Comments on „Energy Star Program Requirements for Computer Servers – Draft 3“

Bernd Schäppi and Thomas Bogner

Fig. Relationship between on_max, rated PSU power etc.

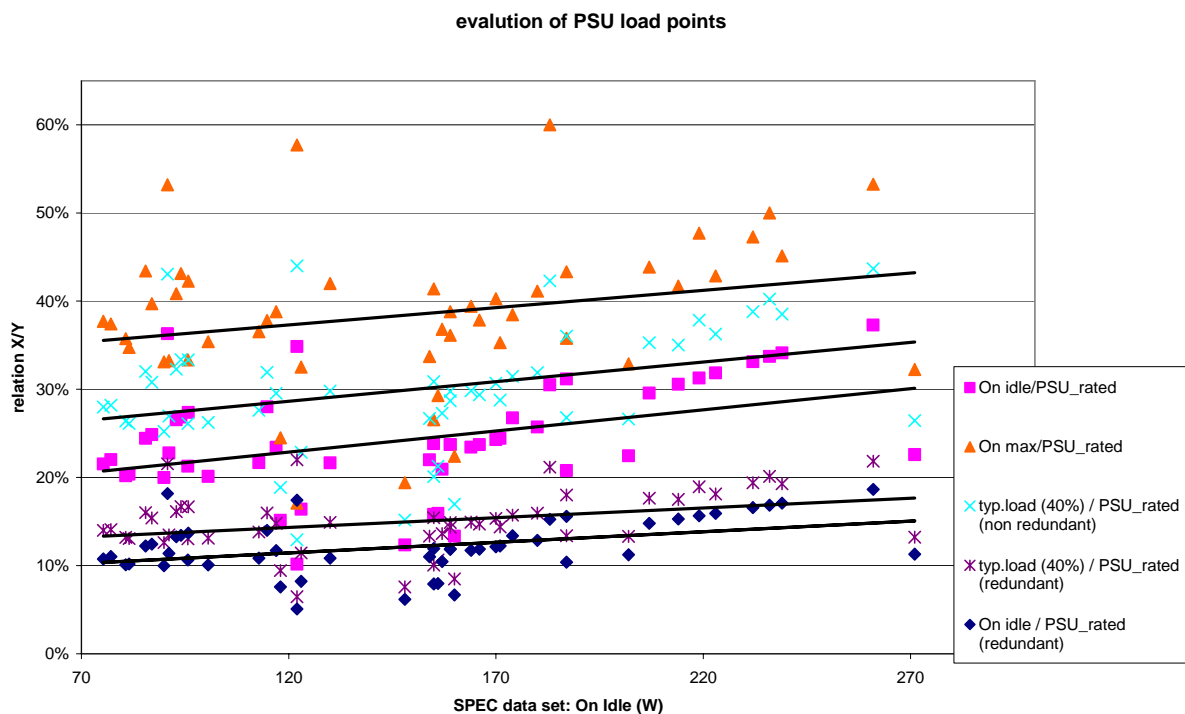
Calculations for typical server configurations (modified data from SPECpower) show that max power (at maximum workload) is often only 45 - 50 % of max rated PSU power (non-redundant situation). In case of redundancy the gap between maximum rated power and maximum required power is even bigger.

It is sometimes argued that power supply capacity must meet power demand also for high configurations of servers and consequently in case of upgrading. Alternatively different sizes of power supplies for different configurations could be offered. Since manufacturers offer online tools for server configuration an adequate sizing of the power supply should be

possible. For the moment the major problem is the limited availability of different sizes of power supplies especially in the low-end power segment.

There following potential approaches which could provide an incentive to avoid oversizing of power supplies could be discussed.

- Defining a maximum ratio of PSU rated power and max active power at full work-load and typical (and high) configuration.
- Introducing an additional size class for power supplies. Additional power supply classes may be introduced (e.g. <400W, 400-1000W, >1000W) and 10% requirement would not be valid for the low-end class (smallest power supplies) but only for the other classes. Thus small power supplies would have no 10% requirement since they anyway will be operated at higher power loads in practice.
